**Project:** Bear Creek High School Agricultural Science Building  
Increment 1

## **ADDENDUM 2**

**Revision:** 01/22/2024

Addendum 2

PROJECT NO: 2020-40119  
DATE ISSUED: 02-17-2021  
SCALE: 1" = 1'-0"  
SHEET NUMBER: **F5.00**  
SHEET TITLE: IRRIGATION PLAN

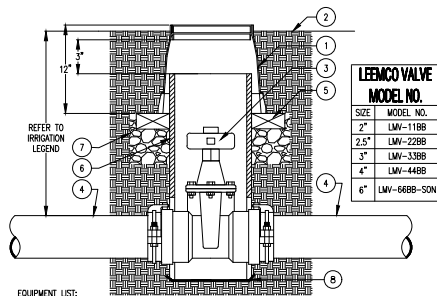
- 1. Q: How should the irrigation under the footprint of the new building be handled?

A: Refer to the attached reference drawings F5.00, F5.01, F5.02, F5.03, F5.04, F5.05, and F5.06 depicting the current irrigation system in the project area. Reconfigure the existing irrigation system to remove the irrigation system from the footprint of the new building as located in the contract documents. Provide a complete and fully functional irrigation system after reconfiguration. All irrigation components shall match the material standards noted in those reference drawings.
